City of Boise
ADA Assessment

Appendix A–Boise Urban Garden School

Report #TO21-B011

ID: 1850 **Facility:** Boise Urban Garden School

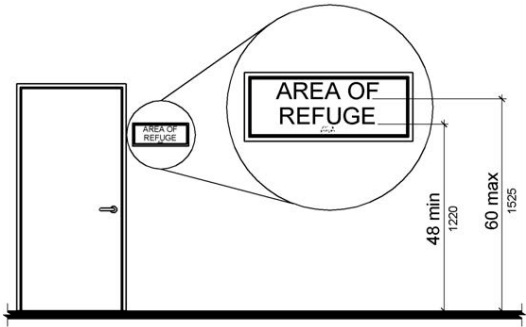
2010 ADA Standards for Accessible Design Codes: §216.2, §703
There is no tactile sign identifying the permanent room.

Install tactile signage on the latch side of the doorway at a height of 48" minimum to 60" maximum above the floor, identifying room by name or room number.
Signs shall be Braille with raised lettering and should be placed on the wall in the center of an 18"x18" clear floor space.

ID: 1870 **Facility:** Boise Urban Garden School

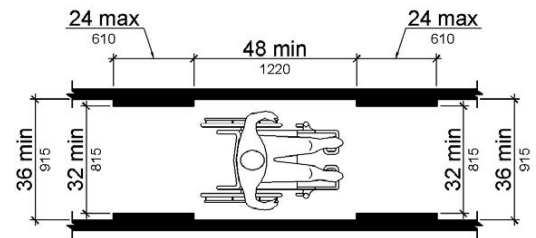
2010 ADA Standards for Accessible Design Codes: §403.5.1
Due to the foliage, there is not a clear 36" width for wheelchairs to pass.

Trim and continue to maintain the foliage as to keep it out of the accessible route.

ID: 1873 **Facility:** Boise Urban Garden School

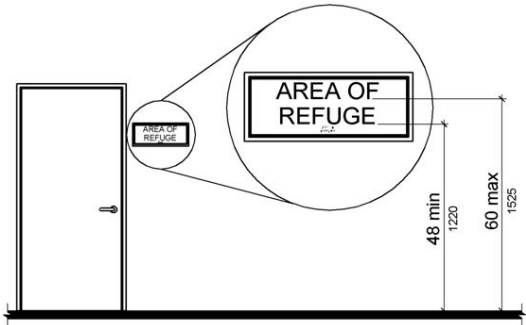
2010 ADA Standards for Accessible Design Codes: §216.2, §703
There is no tactile sign identifying the permanent room.

Install tactile signage on the latch side of the doorway at a height of 48” minimum to 60” maximum above the floor, identifying room by name or room number.
Signs shall be Braille with raised lettering and should be placed on the wall in the center of an 18"x18" clear floor space.

ID: 1878 **Facility:** Boise Urban Garden School

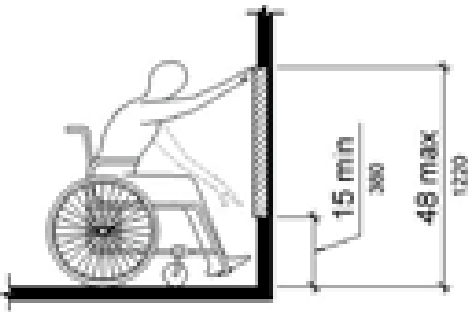
2010 ADA Standards for Accessible Design Codes: §308.2.1
The hooks are outside of the unobstructed forward reach range at 50.5" above the floor.

Lower the hooks by 2.5" to meet the accessible reach range of 48" maximum above the floor.

ID: 1888 **Facility:** Boise Urban Garden School

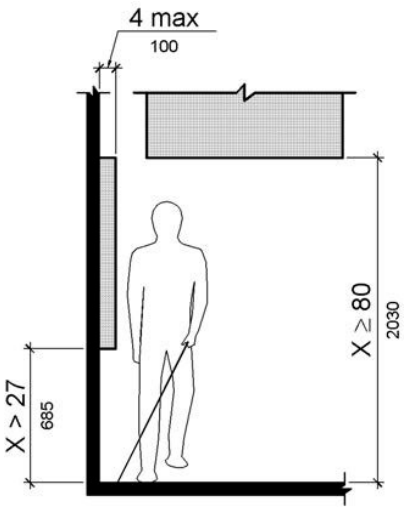
2010 ADA Standards for Accessible Design Codes: §307.2
The silver fire extinguisher protrudes 7" into the circulation space at 29.25" above the floor.

Recess the silver fire extinguisher so it protrudes a maximum of 4", lower it so the bottom edge is 27" maximum above the floor, or place a cane detectable object beneath it.

ID: 1889 **Facility:** Boise Urban Garden School

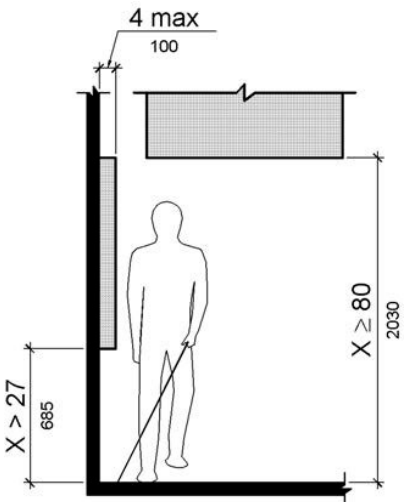
2010 ADA Standards for Accessible Design Codes: §307.2
The red fire extinguisher protrudes 4.25" into the circulation space at 33.5" above the floor.

Recess the red fire extinguisher so it protrudes a maximum of 4", lower it so the bottom edge is 27" maximum above the floor, or place a cane detectable object beneath it.

ID: 1890 **Facility:** Boise Urban Garden School

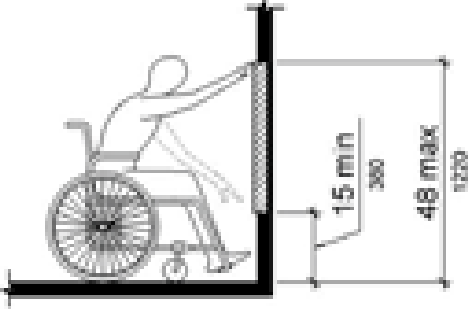
2010 ADA Standards for Accessible Design Codes: §308.2.1, §307.2
 The first aid box protrudes 5.5" into the circulation space at 54.75" above the floor.
 The first aid box is outside of the unobstructed forward reach range at 54.75" above the floor.

Recess the first aid box so it protrudes a maximum of 4", lower it so the bottom edge is 27" maximum above the floor, or place a cane detectable object beneath it.
 Lower the first aid box by 6.75" to meet the accessible reach range of 15" minimum and 48" maximum above the floor.

ID: 1891 **Facility:** Boise Urban Garden School

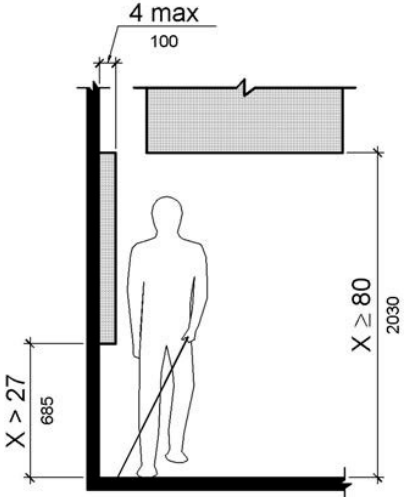
2010 ADA Standards for Accessible Design Codes: §307.2, §308.2.1
The AED is outside of the unobstructed forward reach range at 54.25" above the floor. The AED protrudes 7" into the circulation space at 54.25" above the floor.

Lower the AED by 6.25" to meet the accessible reach range of 15" minimum and 48" maximum above the floor.
Recess the AED so it protrudes a maximum of 4", lower it so the bottom edge is 27" maximum above the floor, or place a cane detectable object beneath it.

ID: 1876 **Facility:** Boise Urban Garden School

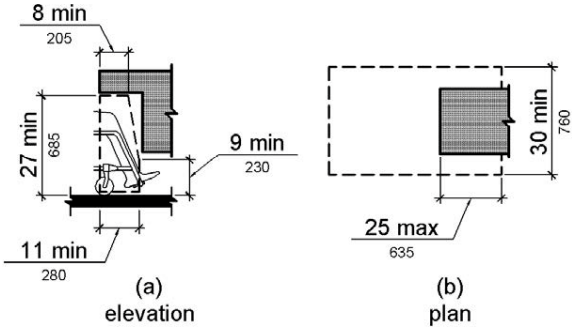
2010 ADA Standards for Accessible Design Codes: §902.3, §306.3.3
There is no knee clearance underneath the sink.
The sink and work surface counter is 36" above the floor.

Provide knee clearance underneath the counter at the sink that is a minimum of 11" deep at 9" above the floor and 8" deep at 27" above the floor.
A 30" portion of the work surface must be no higher than 34" above the floor. Lower the sink to the maximum height of 34" above the floor.

ID: 1872 **Facility:** Boise Urban Garden School

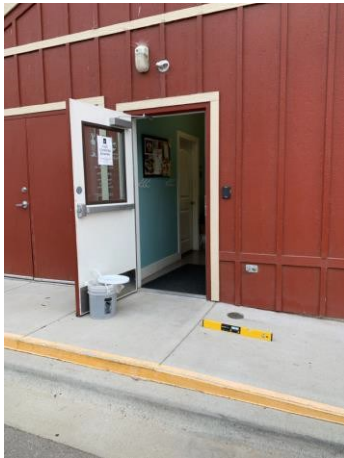
2010 ADA Standards for Accessible Design Codes: §404.2.4.1
There is not adequate maneuvering clearance to operate the door. The maneuvering clearance to operate the door has a 5.3% slope.

Reconstruct the sidewalk to ensure that the maneuvering clearance extends 24" to the latch side of the door and has a maximum slope of 2% in all directions.

ID: 1853 **Facility:** Boise Urban Garden School

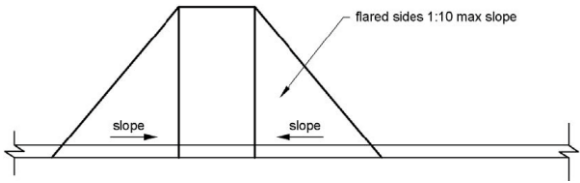
2010 ADA Standards for Accessible Design Codes: §406.4, §406.3
The curb ramp flares have a 10.9% slope.
There is no landing provided at the top of the curb ramp.

Resurface the curb ramp flares to ensure a maximum slope of 10%.
Create a parallel curb ramp to allow for a wheelchair user to turn within the ramp to go left or right out of the detectable warning area.

ID: 1885 **Facility:** Boise Urban Garden School

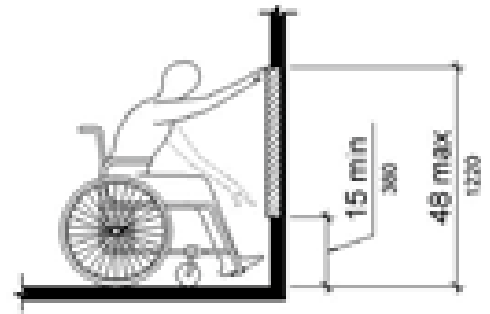
The paper towel dispenser is outside of the unobstructed forward reach range at 49" above the floor.

Lower the paper towel dispenser by 1" to meet the accessible reach range of 48" maximum above the floor.

ID: **Facility:**
Boise Urban Garden School

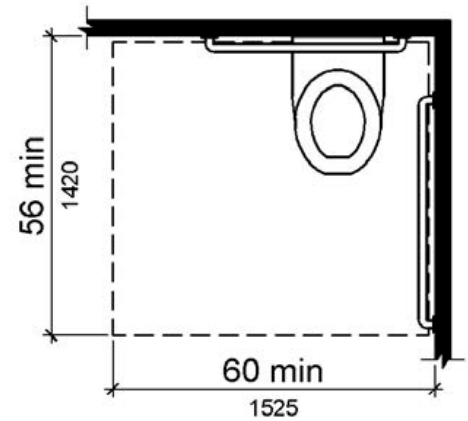
2010 ADA Standards for Accessible Design Codes: §604.3.1
The clearance around the water closet is less than 60"x56" when measured perpendicular from the side wall and rear wall due to the stored items.

Remove the boxes and other stored items from the restroom.

ID: 4473 **Facility:** Boise Urban Garden School

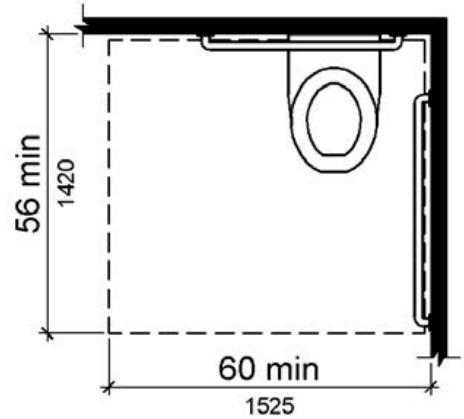
2010 ADA Standards for Accessible Design Codes: §604.3.1
The clearance around the water closet is less than 60"x56" when measured perpendicular from the side wall and rear wall due to the stored items.

Remove the stored items from the restroom.

ID: 1892 **Facility:** Boise Urban Garden School

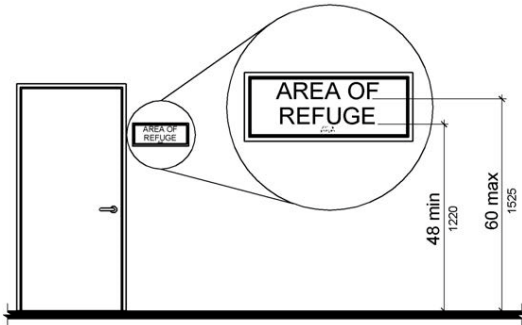
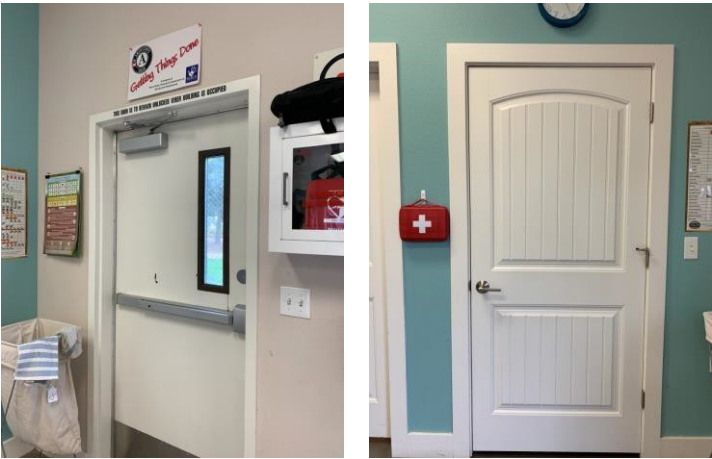
2010 ADA Standards for Accessible Design Codes: §216.2, §703
There are no tactile signs identifying eight permanent rooms.

Install tactile signage on the latch side of the doorway at a height of 48” minimum to 60” maximum above the floor, identifying room by name or room number. Signs shall be Braille with raised lettering and should be placed on the wall in the center of an 18"x18" clear floor space.
